Exhibit F - Schaap Center Flooding Risk Evaluation - Page 1 of 17

Schaap Center Flooding Risk Evaluation

September 17, 2021

Spot Elevations Check

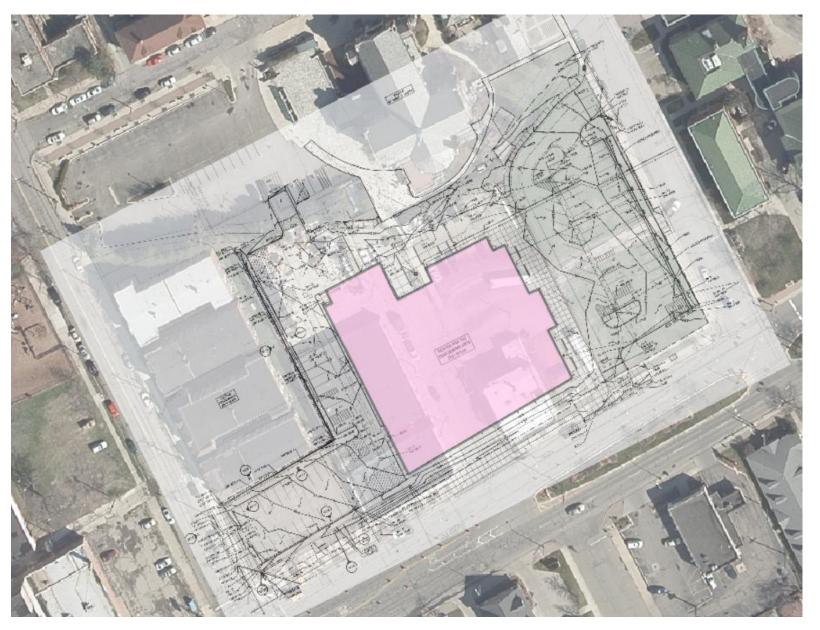
- LiDAR data was checked against surveyed spot elevations
- Elevation differences ranged from 0-ft to 0.5-ft
- LiDAR data trended higher than survey data

Surface Flow Directions (Proposed Grading)

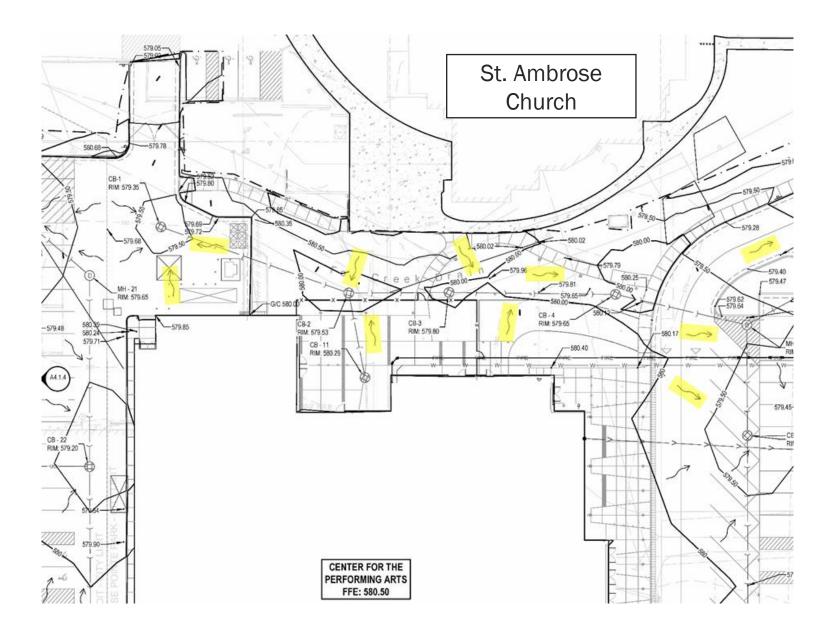
- Proposed grading is lower than door thresholds
- Flow is directed toward proposed catch basins
- Surface grading does not increase flow toward St. Ambrose Church

June 25, 2021 Estimated Extent of Flooding

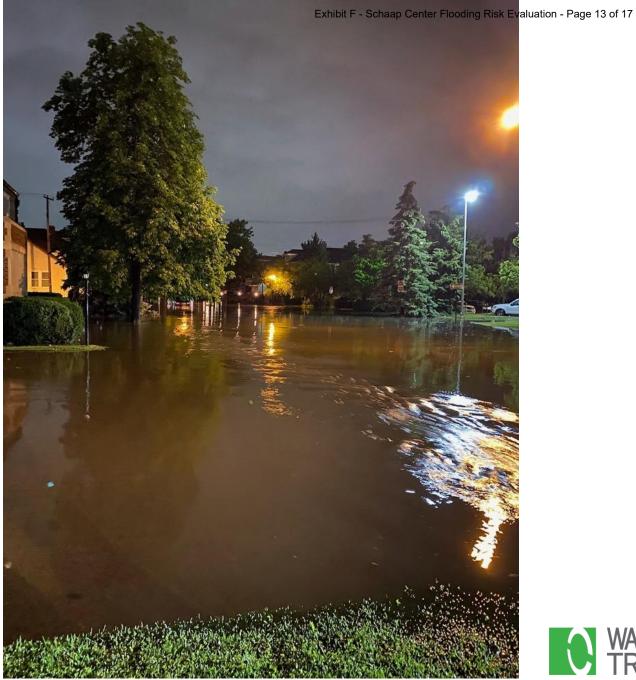
- Flood elevation was determined to be 578.5' based on photo and LiDAR data
- Areas below 578.5' are shaded in orange
- Flooded area is not overlapping with Schaap Center footprint
